Berlin Planning and Zoning Commission Agenda November 19, 2020

Site Plan Amendment

Project Name: Sliders Sports Bar and Grill – Outdoor Patio

Site Plan Amendment - modification to approved plan

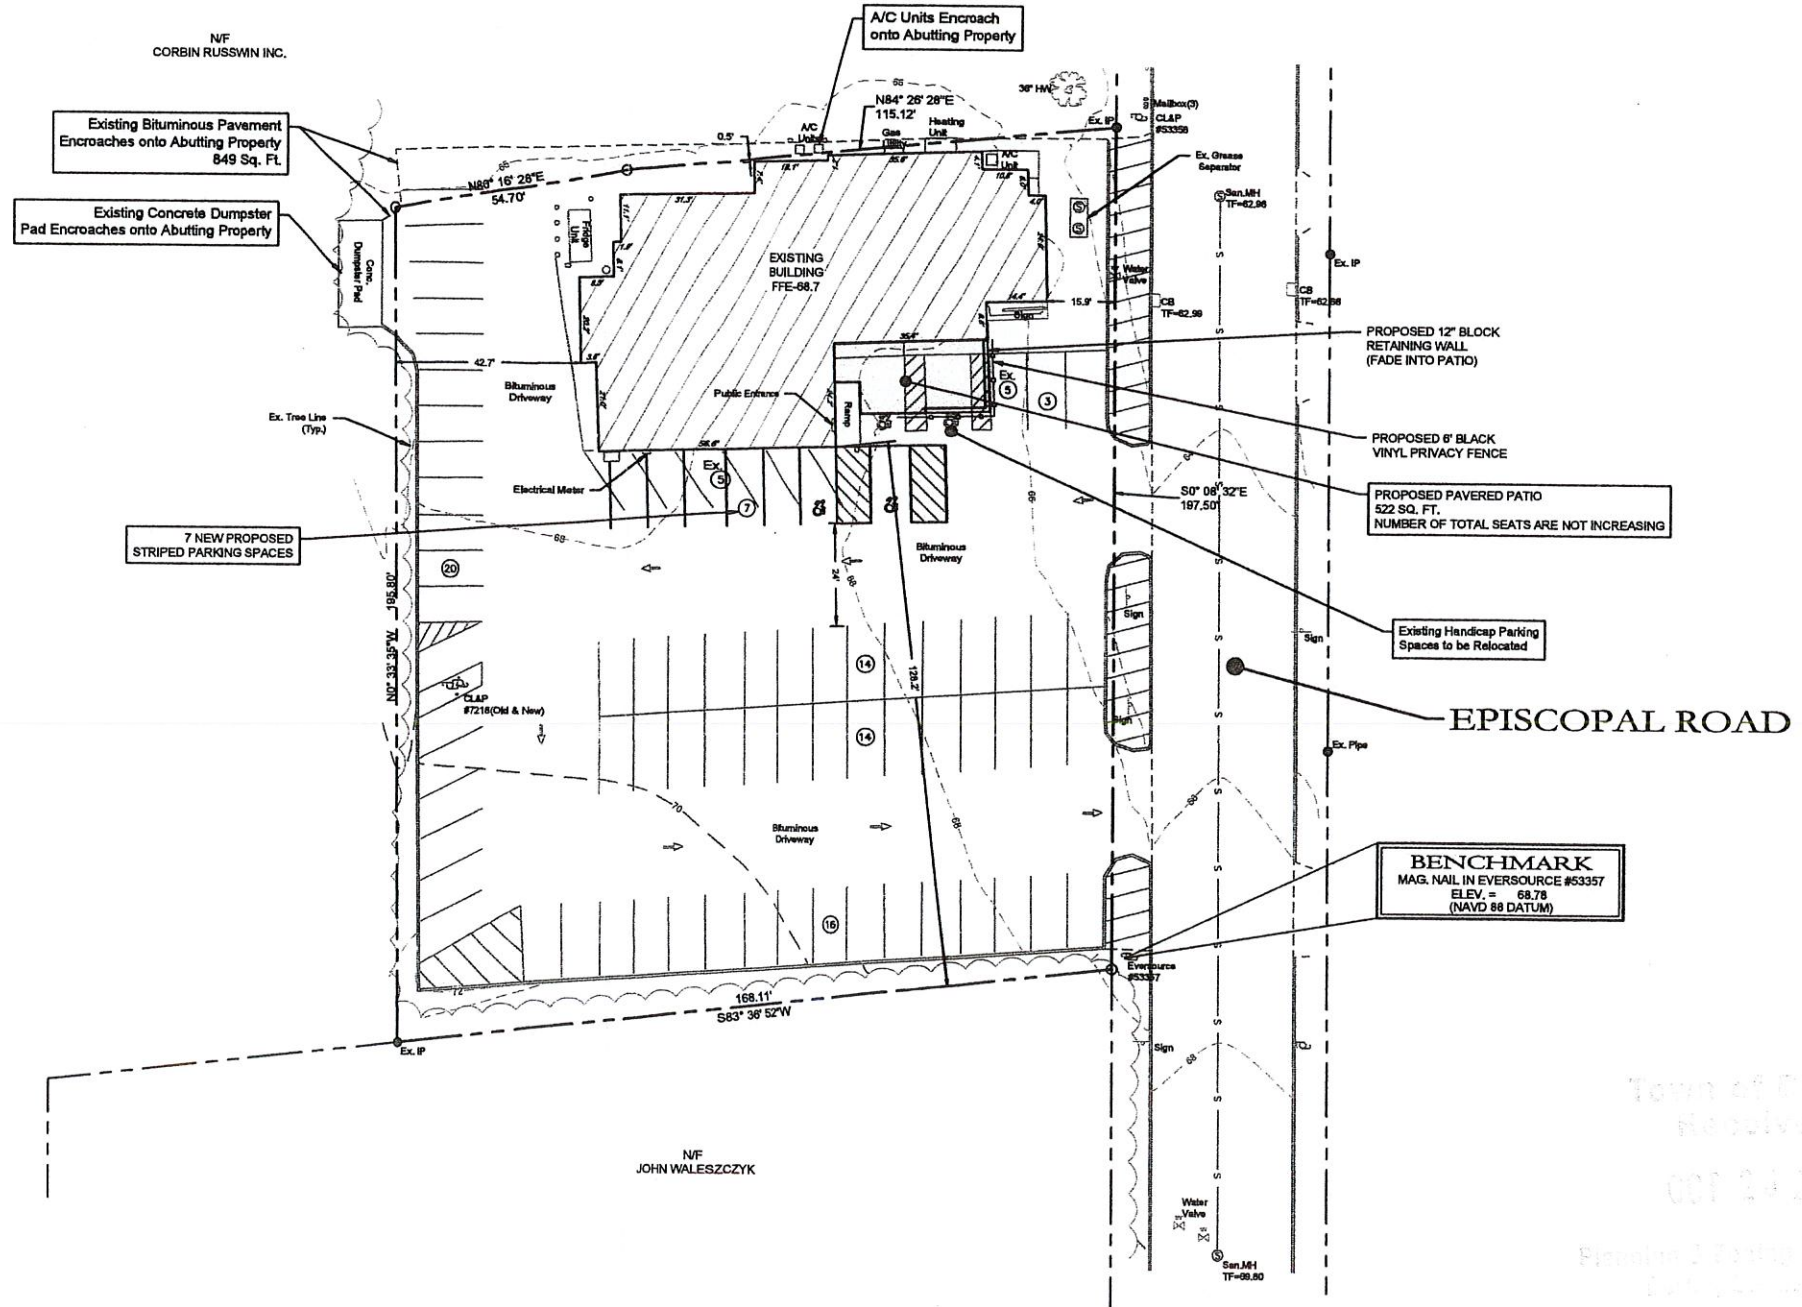
1. The scale and property identifier on the plan be corrected. The correct parcel annotation is Map 4-4, Block 81, Lot 7.
2. A complete zoning chart, including identification of nonconformities be added to the plan.
3. Appropriate patio service approval and licensing to be obtained for any liquor service to the patio area, including required Zoning Board of Appeals approval for the patio liquor permit.

4. Health District comments regarding patio drink service be resolved to their satisfaction, if applicable.
5. Emergency lighting be added per Fire Marshal comments.
6. Any change to the seating resulting in an increased occupancy will require zoning review, including to demonstrate compliance with the parking requirements.
7. Any outstanding staff and department comments be resolved

Exit marking emergency lighting required – as noted on plan (attached)

04 OF 09

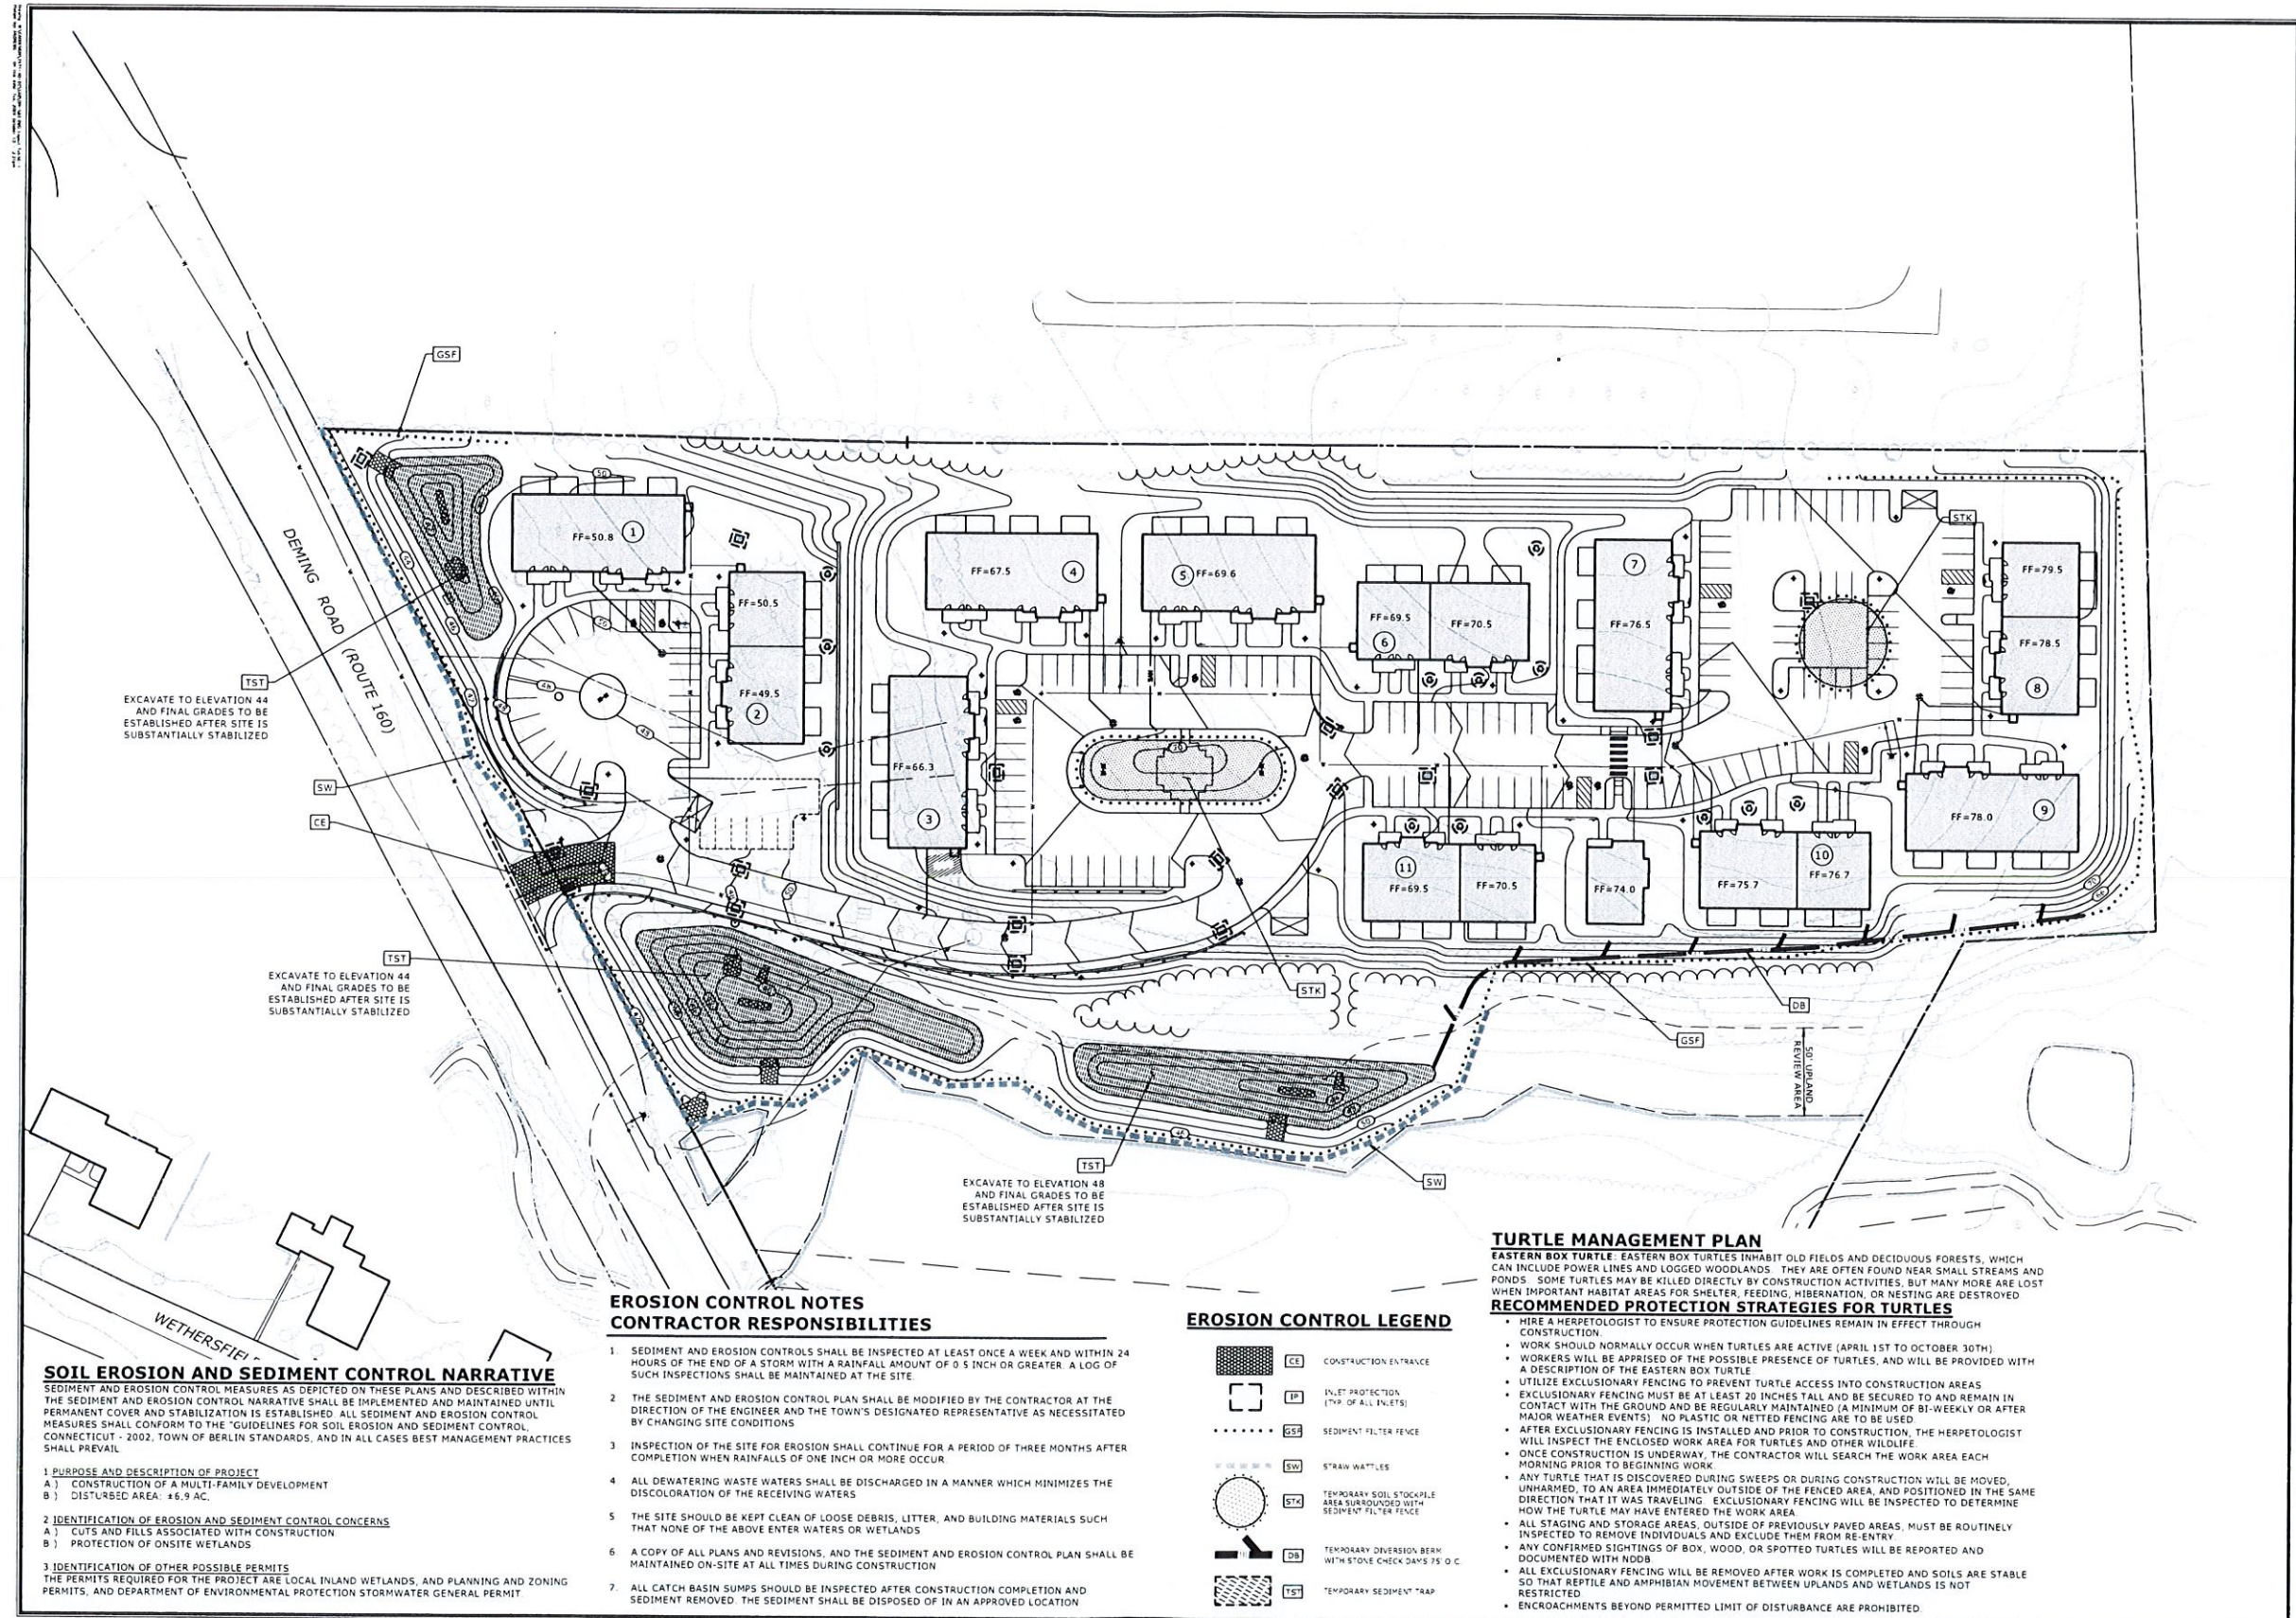
- 1) Apparently, sewer line from fitness building was not shown.
- 2) We will develop a DPA (Developer's Permit Agreement) to define materials and our expectations for ownership and operation of water/sewer system
- 3) Plan should also show water/fire line service and meter locations on each of the buildings similar to Fieldstone Project

- 1) Clubhouse shows water service line but no sanitary lateral ((Sheet 04). Coordinate details with Berlin Water Control.

Note to Planning & Zoning Commissioners: Ray Jarema (Water Control) is working with their engineer on water/sanitary, so this comment is not meant to hold up site plan approval)
